A/TM-LTTY/487

回應各部門的提問

## A/TM-LTTY/487

# ATM-LTTY/487 消防裝置建議圖

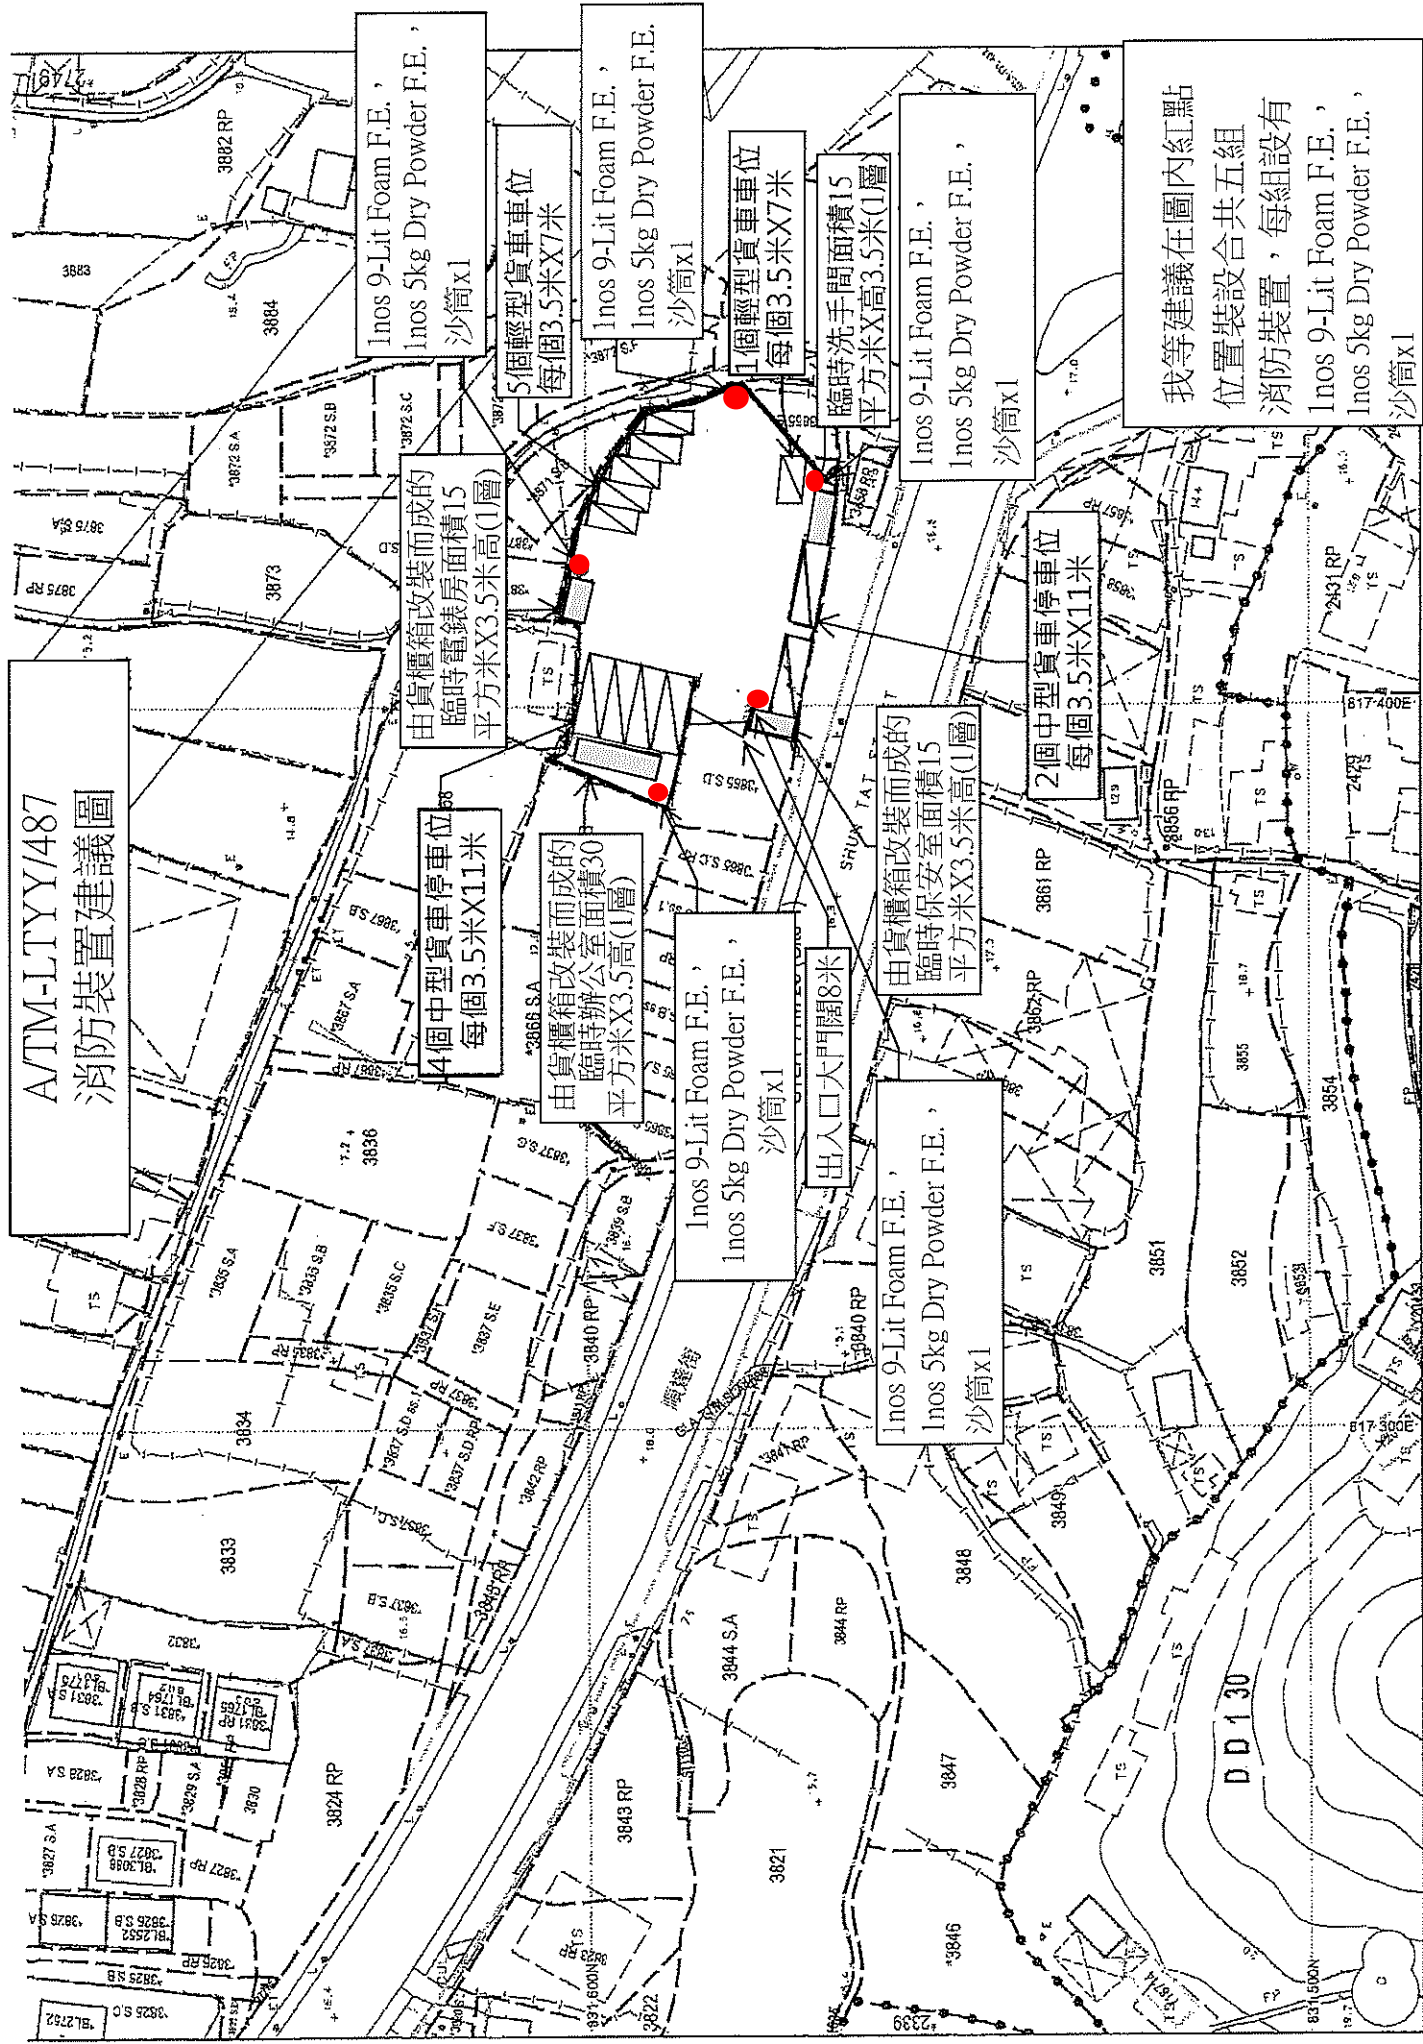
In consideration of the design/nature of the proposal, FSIs are anticipated to be required. Therefore, the applicant is advised to submit relevant layout plans incorporated with the proposed FSIs to this Department for approval. In addition, the applicant should also be advised on the following points:

- i) The layout plans should be drawn to scale and depicted with dimensions and nature of occupancy; and
- ii) The location of where the proposed FSI to be installed should be clearly marked on the layout plans.

我等申請的停車場實為一般停車場，不會存放有危險物品及化學品的貨物，而有關的構築物全部為貨櫃箱改裝而成並不須要進行任何搭建工序。  
同時我等會提供一份新的消防建議圖給貴署審議。
